CITY OF SANTA FE, NEW MEXICO

Case number: **2020-002810-HDRB**
Project Type: HDRB

PROJECT LOCATION (S): **586 Camino Del Monte Sol**

memo

EXISTING AND PROPOSED SITE PLAN

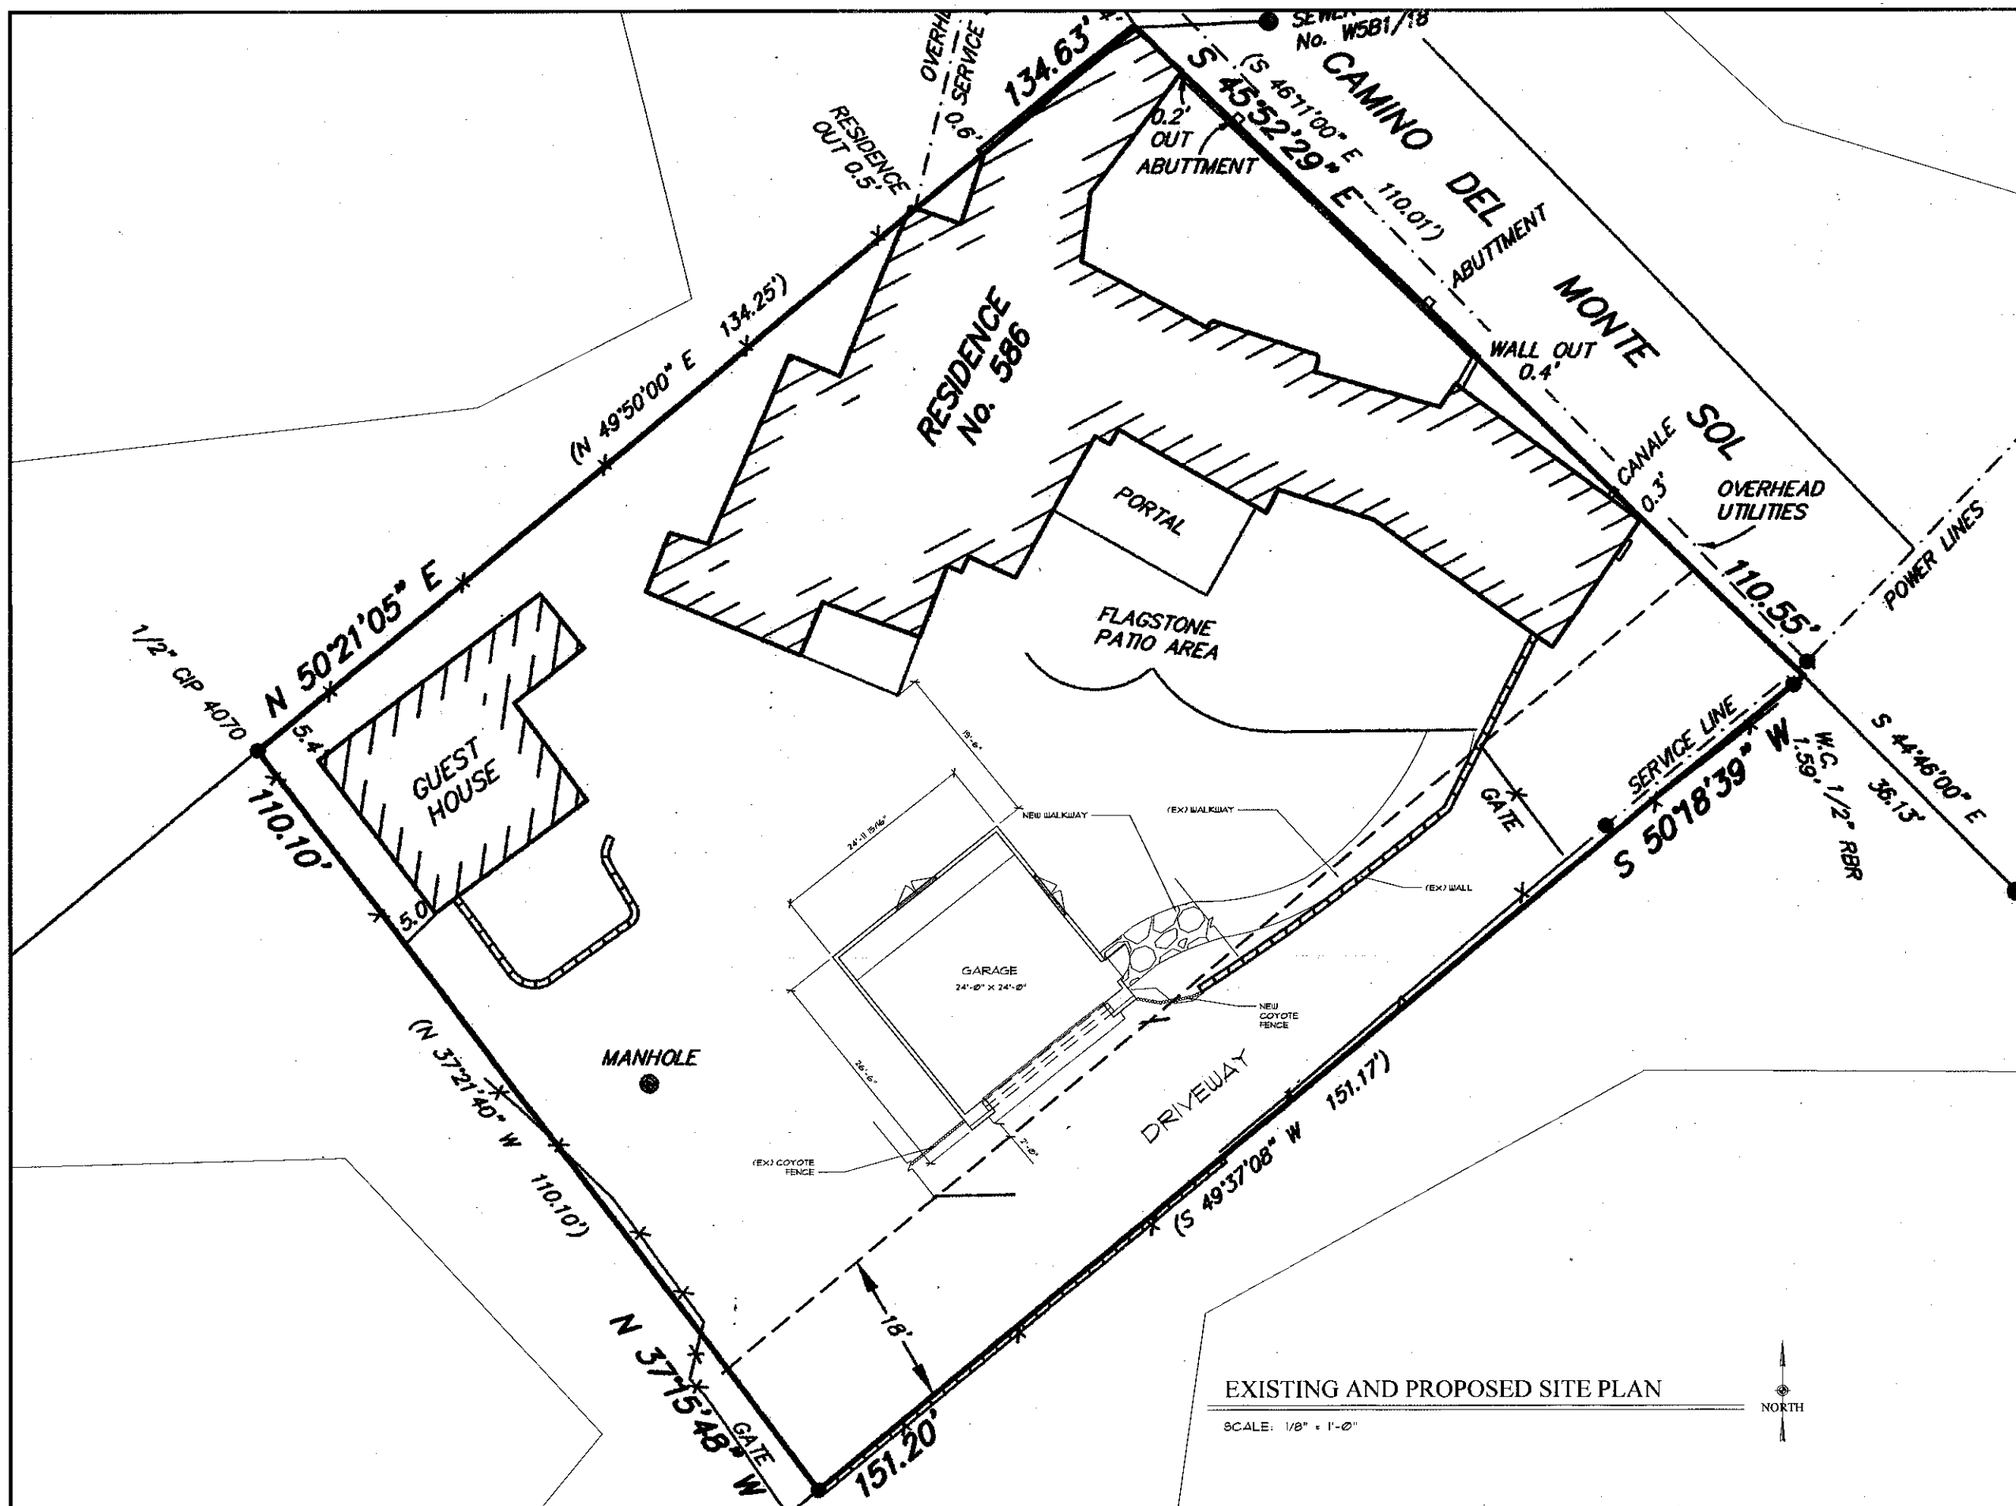
The applicant also proposes to add a 6' tall coyote fence where the maximum allowable height is 6'. The latillas will have staggered tops to create a new parking space for the existing guest house. The new fence will tie into the existing coyote fence that separates the driveway from the yard.

PROPOSED FLOOR PLAN AND ELEVATIONS

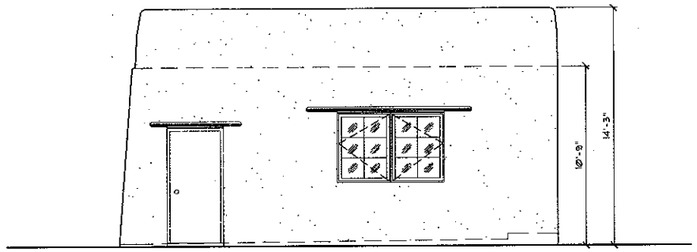
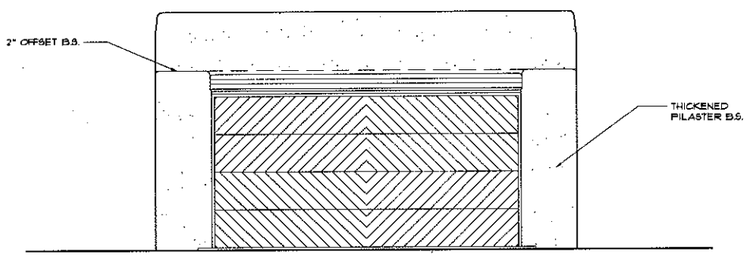
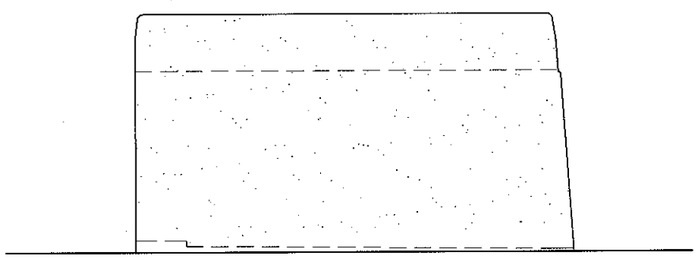
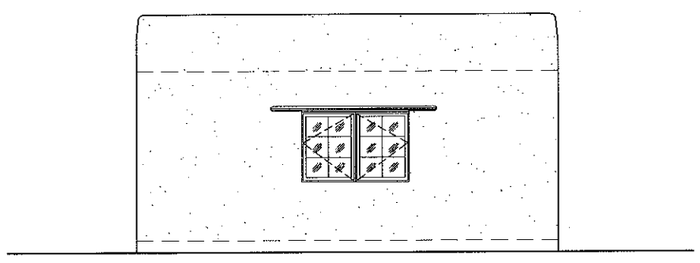
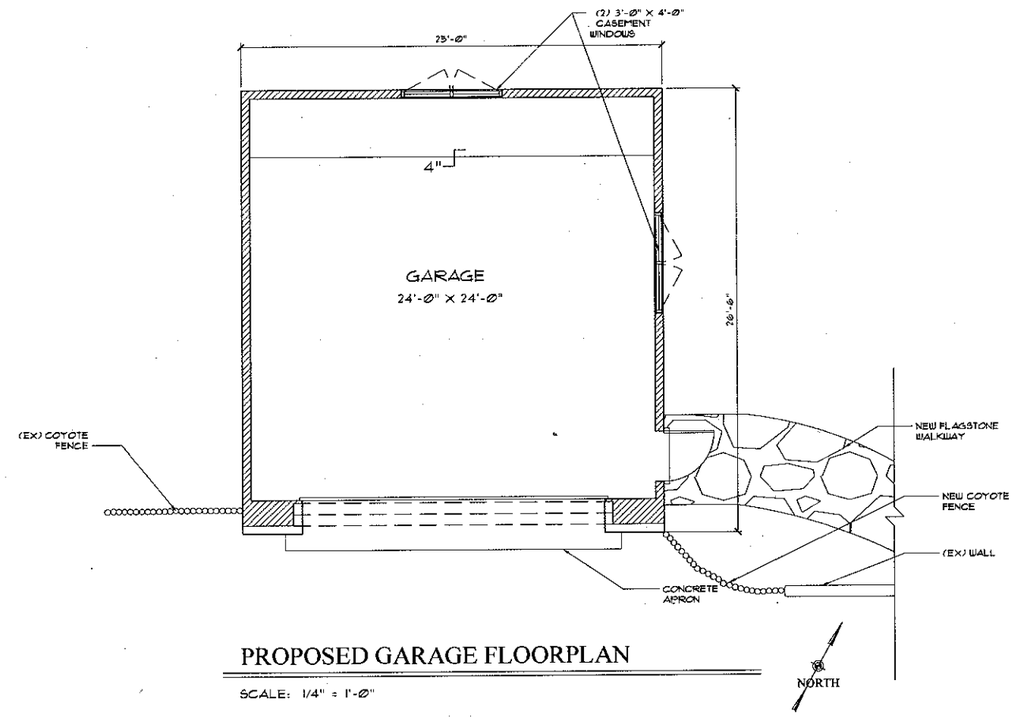
The applicant proposes to construct a 576 sf 14' x 4" high free-standing garage where the maximum allowable height is 15'. The garage will be located to the southwest of the main house. The proposed garage will match the Spanish-Pueblo Revival style of the main house. The garage door will be 19' wide x 9' tall with decorative wood panels and exposed wood lintels on its south façade. The windows and the door will have exposed wood lintels. The north elevation will have a wooden 3' x 4' double casement window with true divided lites painted Danube blue to match main house. The wood doors and lintels will be stained Antique Walnut to match the existing courtyard gate. The stucco will match main house and yard walls, El Rey Buckskin. Garage door will be stain grade cedar fencing. .

Staff recommends approval of the proposal and finds that the application complies with Section 14-5.2(E) Downtown and Eastside Design Standards.
